ADDENDUM NO. 3

Client: City of Elwood
Municipal Building Renovation

Issue Date: November 2, 2026

SHEET NUMBER:
PD100A

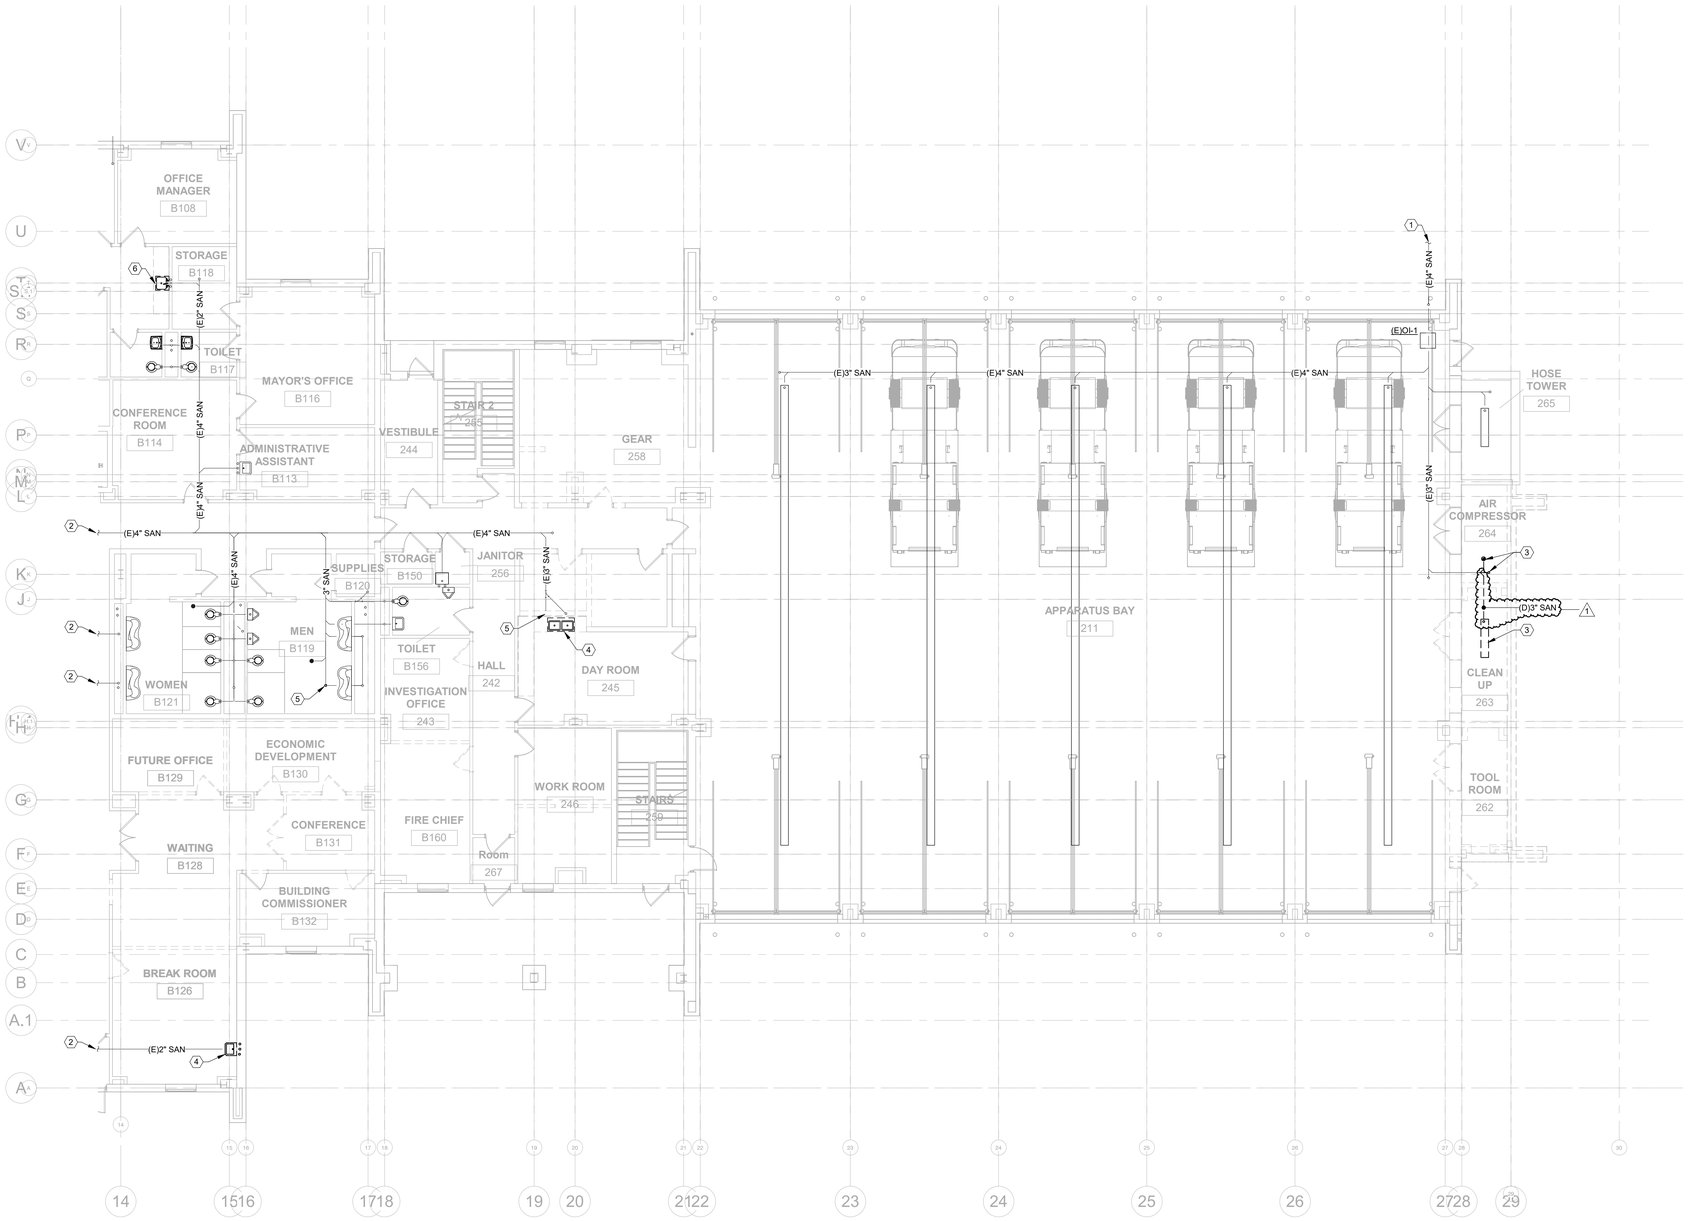
24. **Sheet No. PD100A – Underslab Plumbing – Demolition – Area A**

a. Modified note 1.

SHEET NUMBER:
PD100B

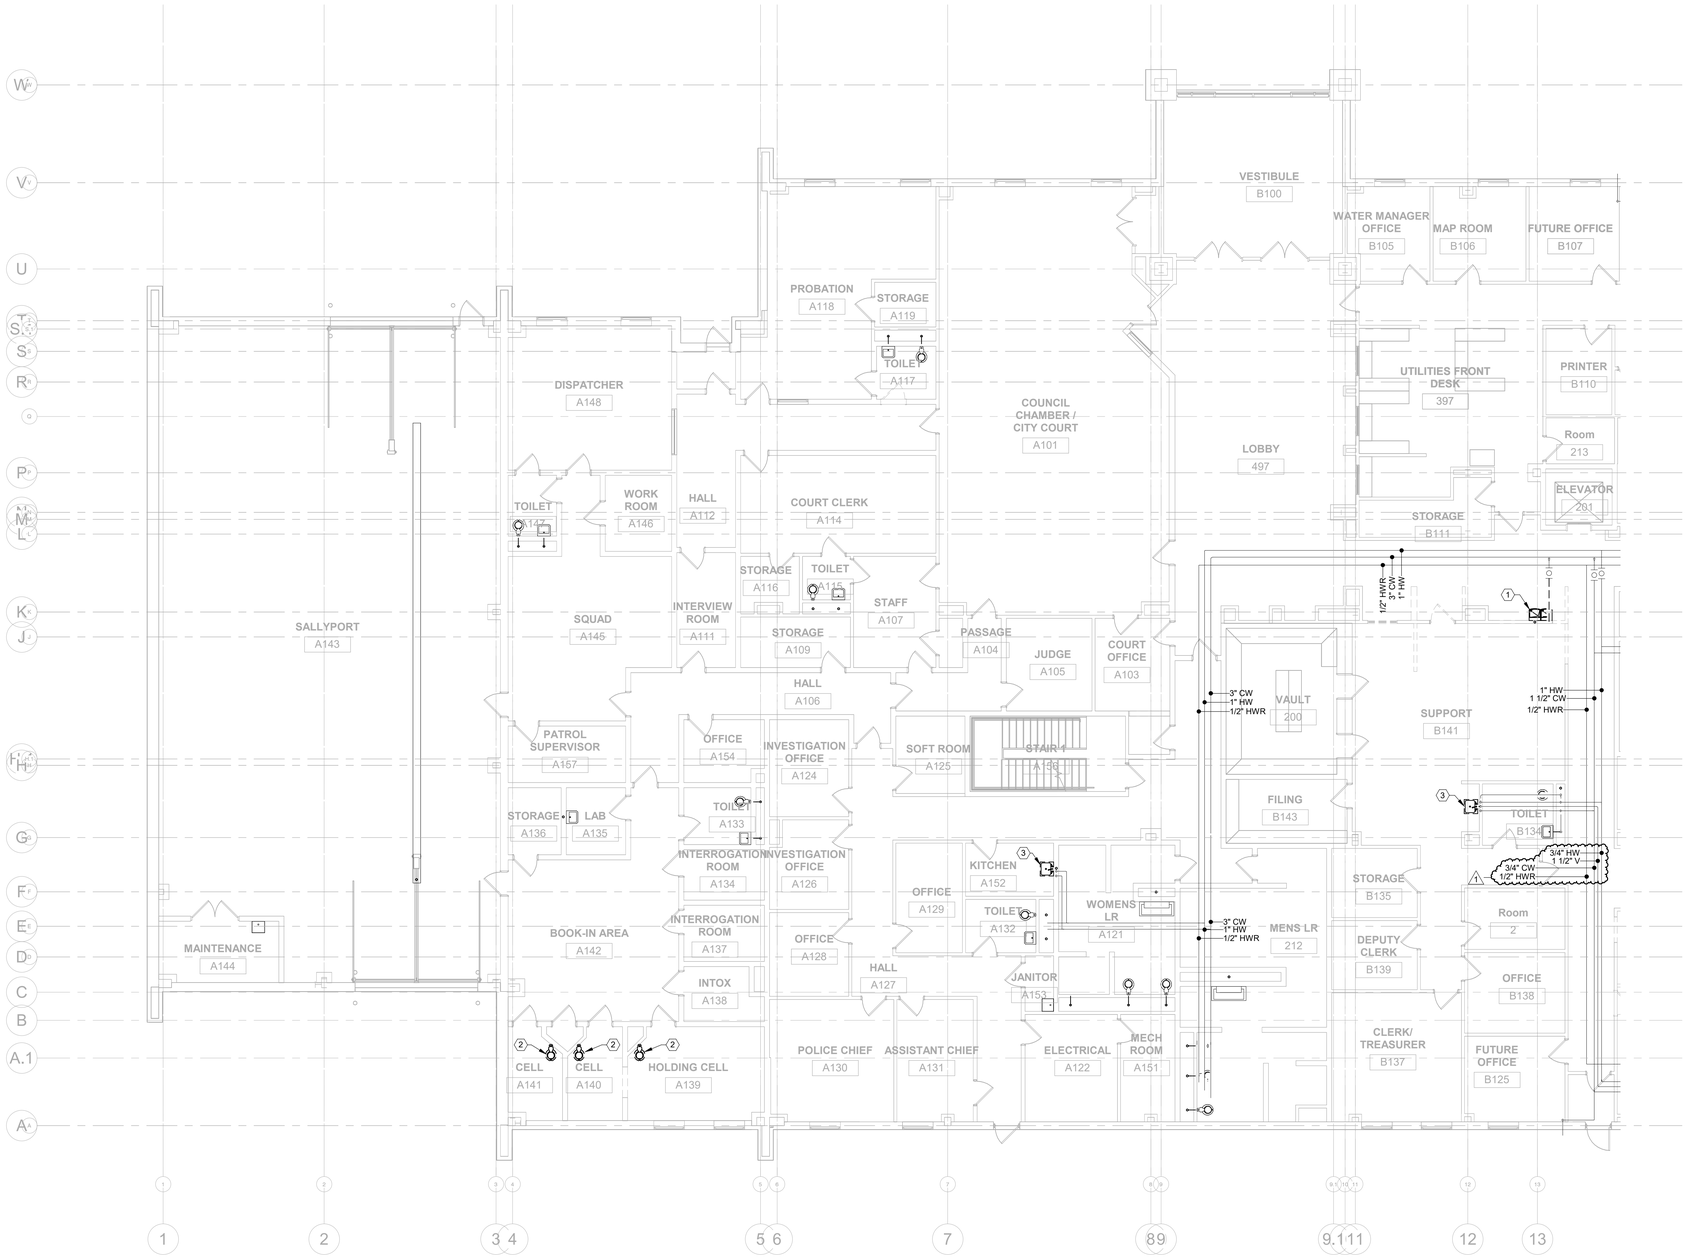
25. **Sheet No. PD100B – Underslab Plumbing – Demolition – Area B**

a. Added 3” sanitary piping for trench drain.

SHEET NUMBER:
PD101A

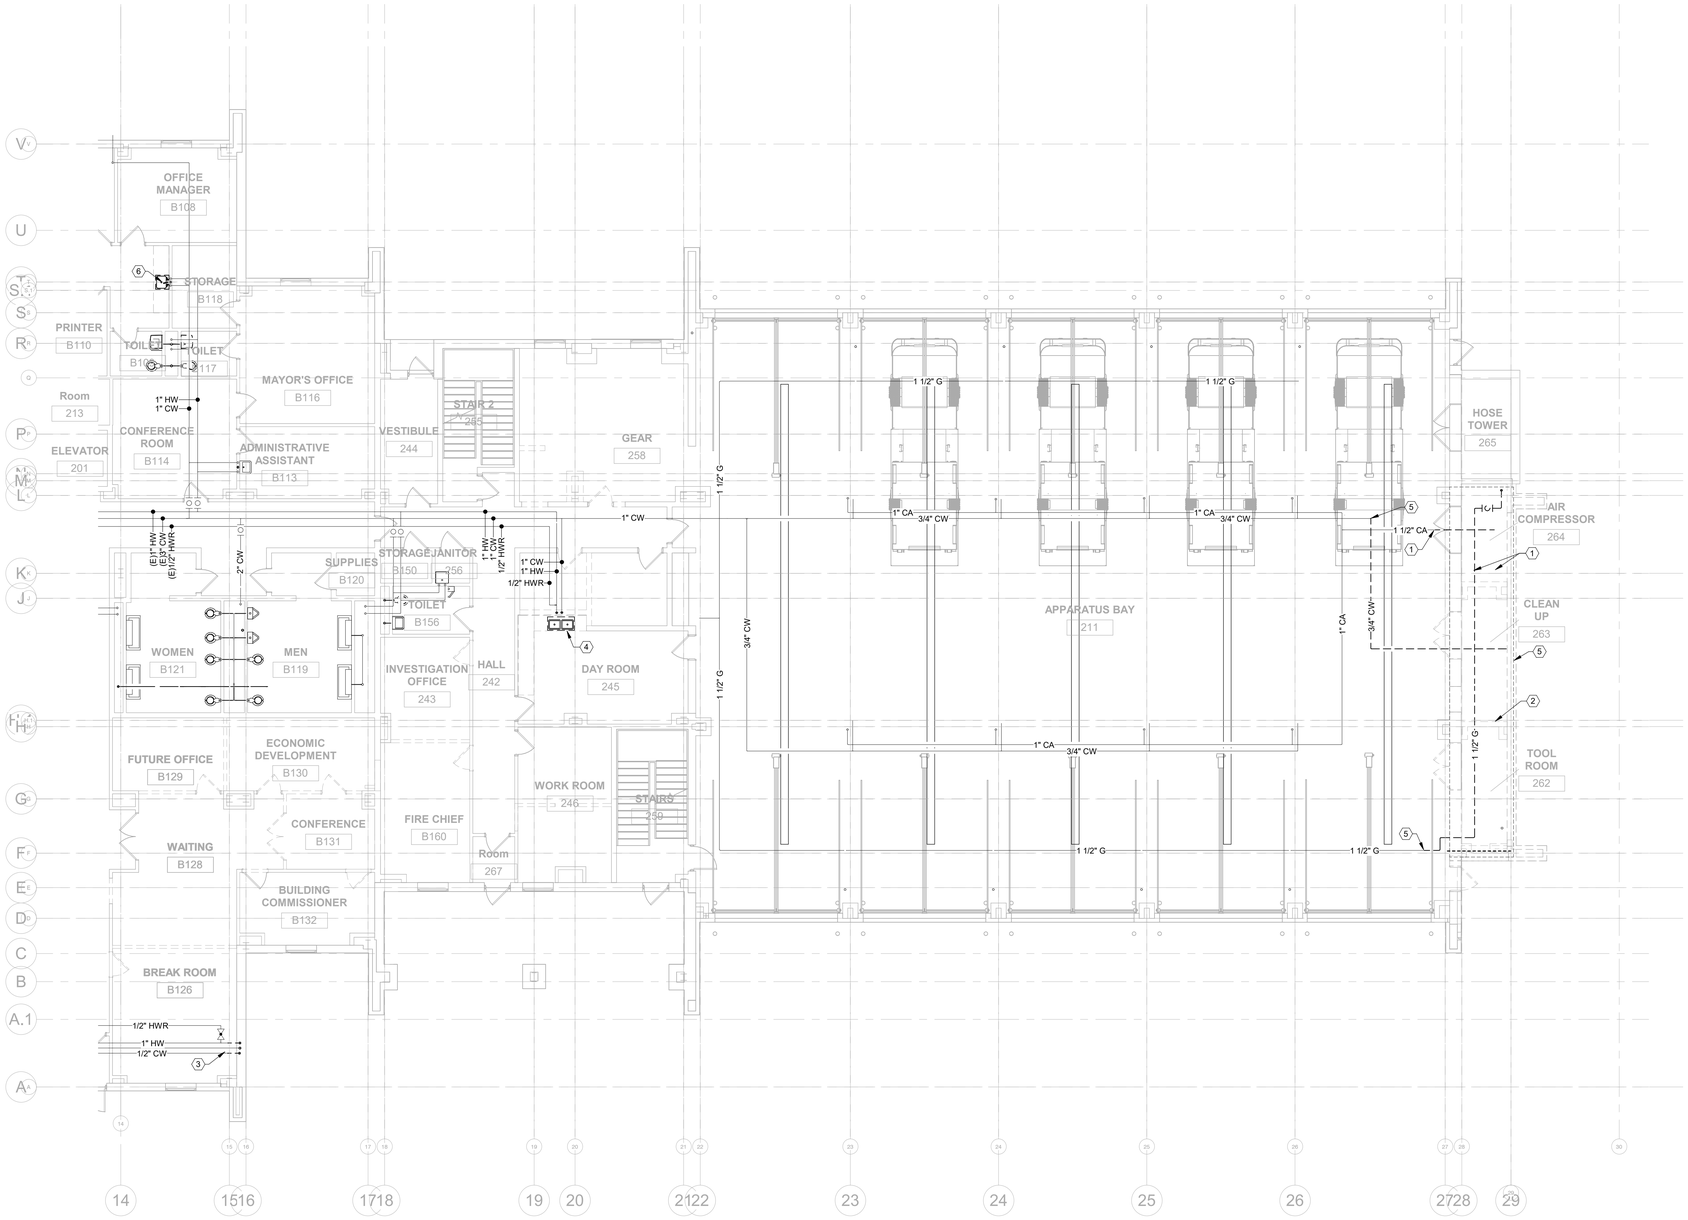
26. **Sheet No. PD101A – 1ST FL Plan Plumbing – Demolition – Area A**

a. Removed note 4.
b. Added pipe tags.

SHEET NUMBER:
PD101B

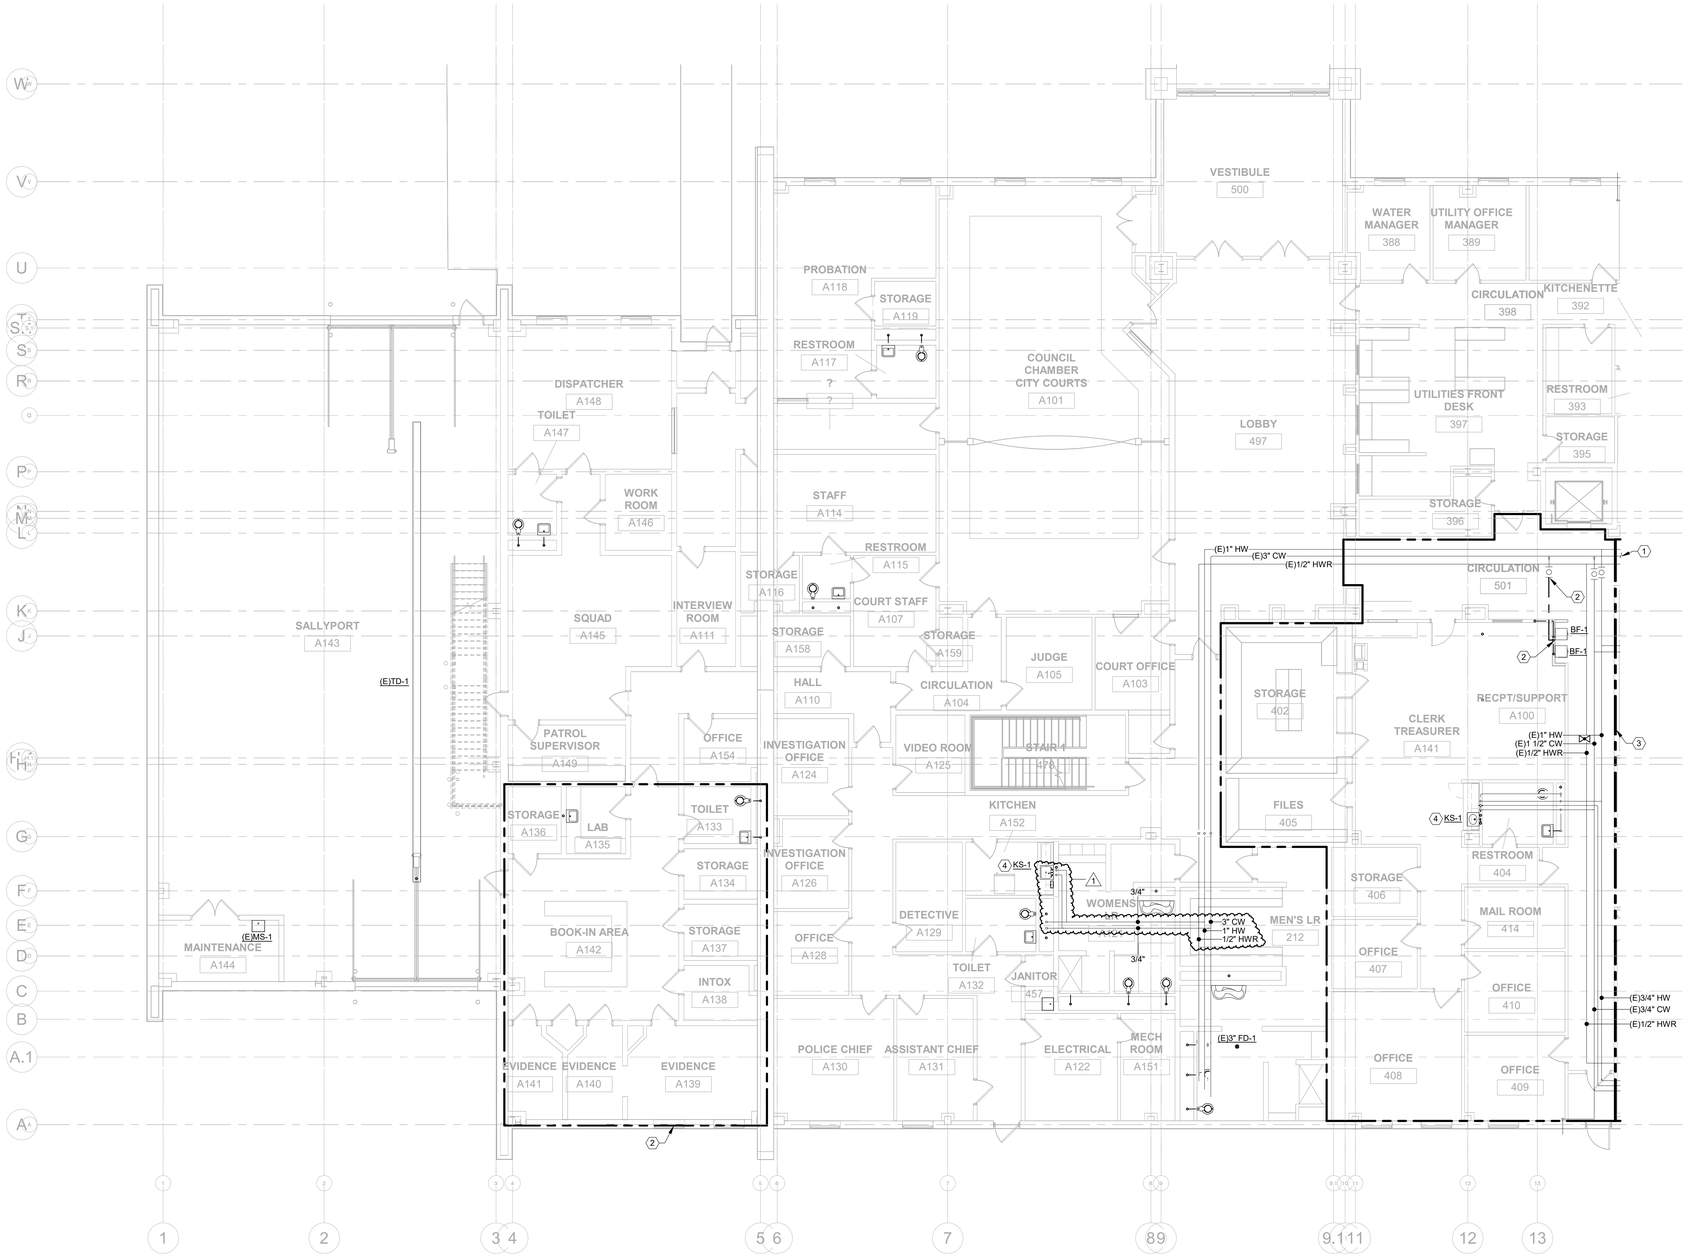
27. **Sheet No. PD101B – 1ST FL Plan Plumbing – Demolition – Area B**
a. Modified note 4.

SHEET NUMBER:
P101A

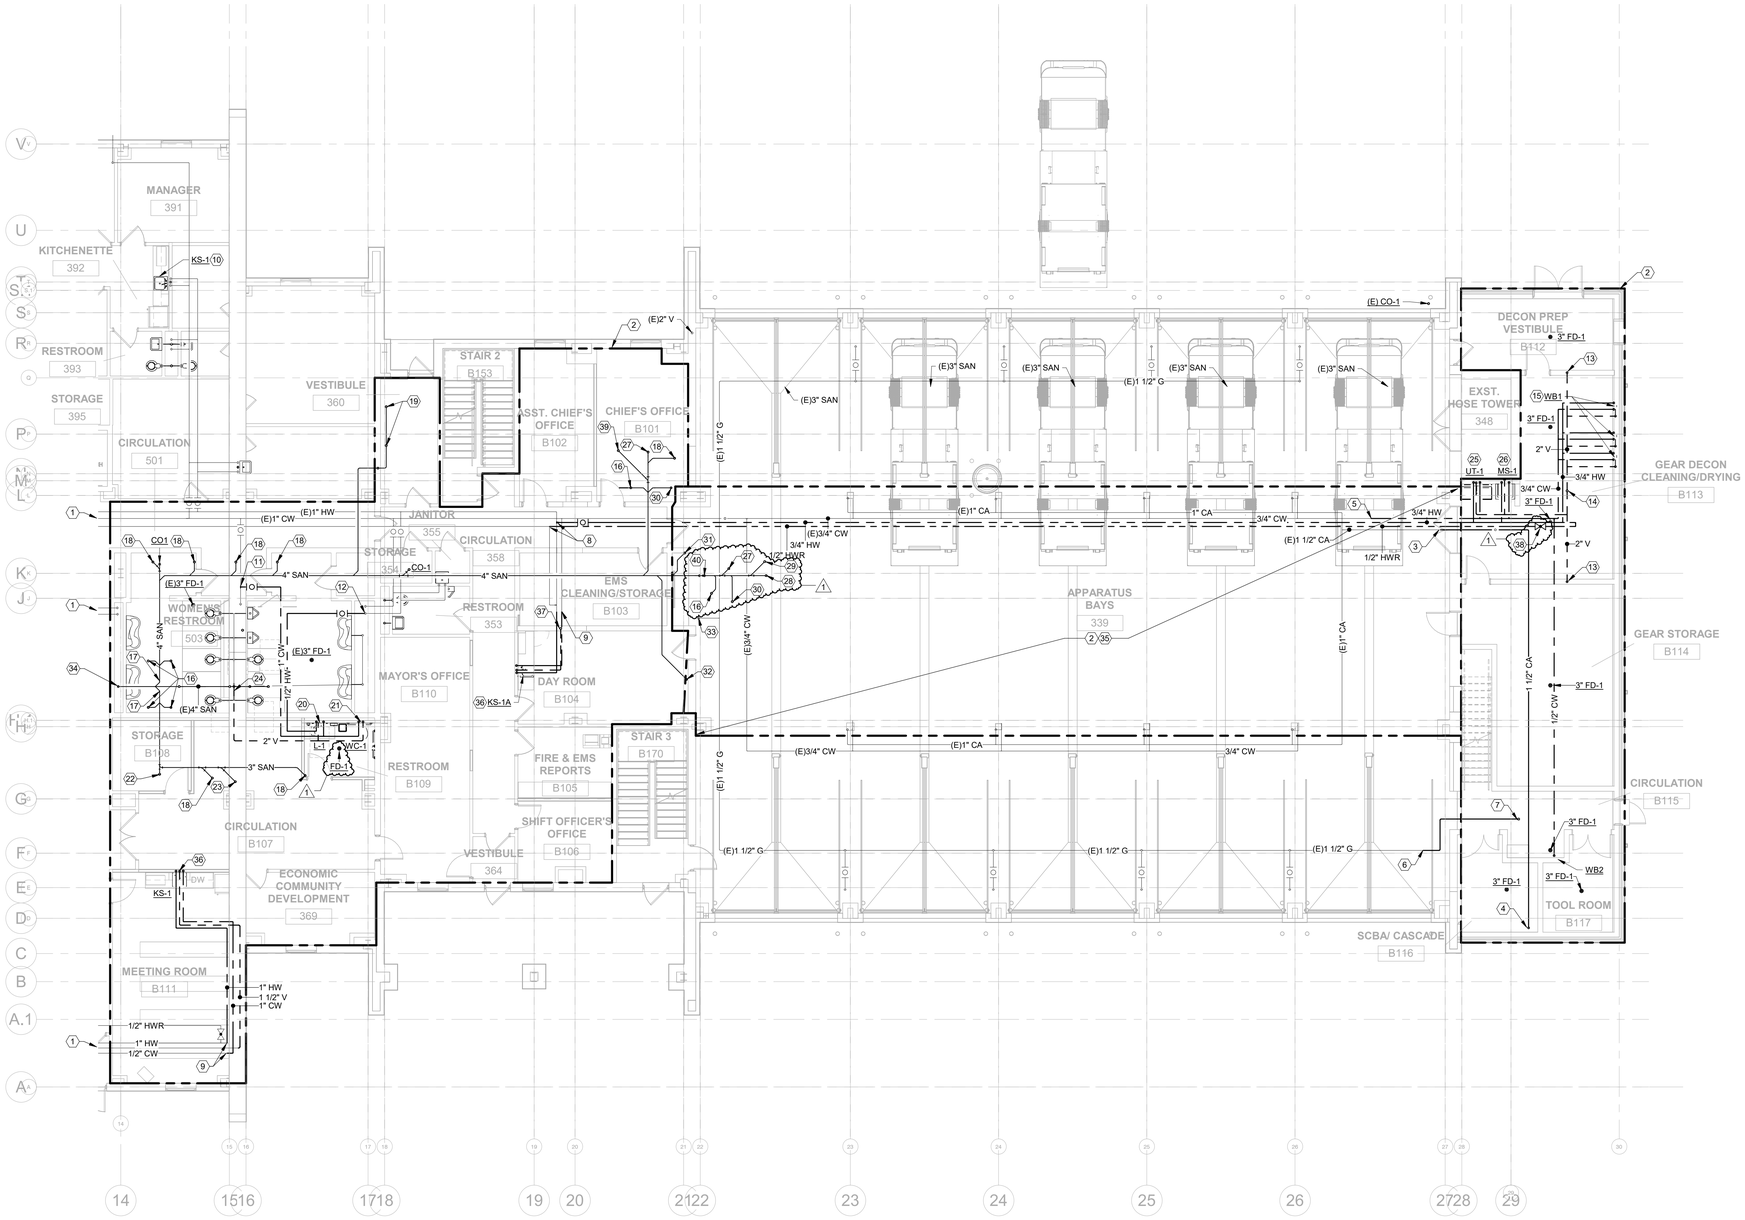
28. **Sheet No. P101A – 1ST FL Plan Plumbing – Area A**
a. Added piping for kitchen sink.
